## CITY COUNCIL MEMORANDUM

**SUBJECT:** PLAT23-0032 Consideration of a request from Stuart Threadgold for a final plat of Lots 9 and 10, Block 1, Oakvale Addition, being 2.0 acres located at 7540 Bursey Road South.

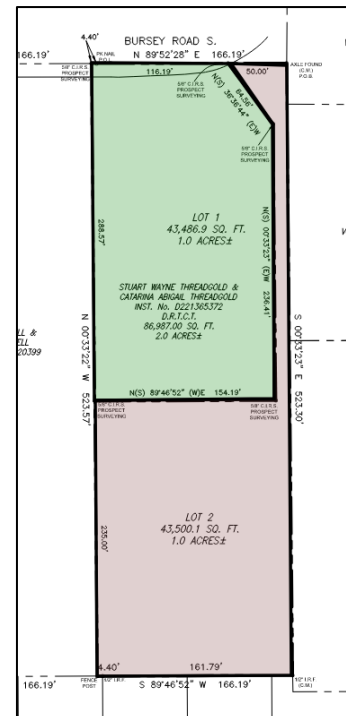
The exhibit to the right shows the proposed lot arrangement. The northern lot (Lot 1) has 116 feet of frontage on Bursey Road South. The southern lot (Lot 2) is proposed as a flag-shaped lot. While flag-shaped lots are permitted, the zoning ordinance and subdivision regulations require that this type of lot provide at least 50 feet of frontage on a public street, with the entire leg of the flag lot maintaining the 50-foot width. The lot has 50 feet of frontage on the street, but the leg of the lot does not meet the minimum 50-foot lot width standard. The narrow portion of the leg is approximately 12 feet wide.

The Planning and Zoning Commission recommended approval of a waiver of the 50-foot lot width standard to allow a 20-foot wide leg on the southern lot. During their discussion, the Commission stated that 20 feet would be sufficient width for a standard driveway and utilities to serve

During the review of the plat, the Development Review Committee (DRC) discussed the effect that the proposed lot arrangement would have on the property. It was noted that the existing property only has 166 feet of street frontage, which is generally not sufficient frontage for more than one standard lot zoned R-1 (Single-Family Residential). In addition, the DRC discussed concerns about the width of the flag on the southern lot.

Approve PLAT23-0032 subject to Development Review Committee comments with a waiver of the 50-foot lot width standard to allow a 20-foot wide leg on the southern lot.
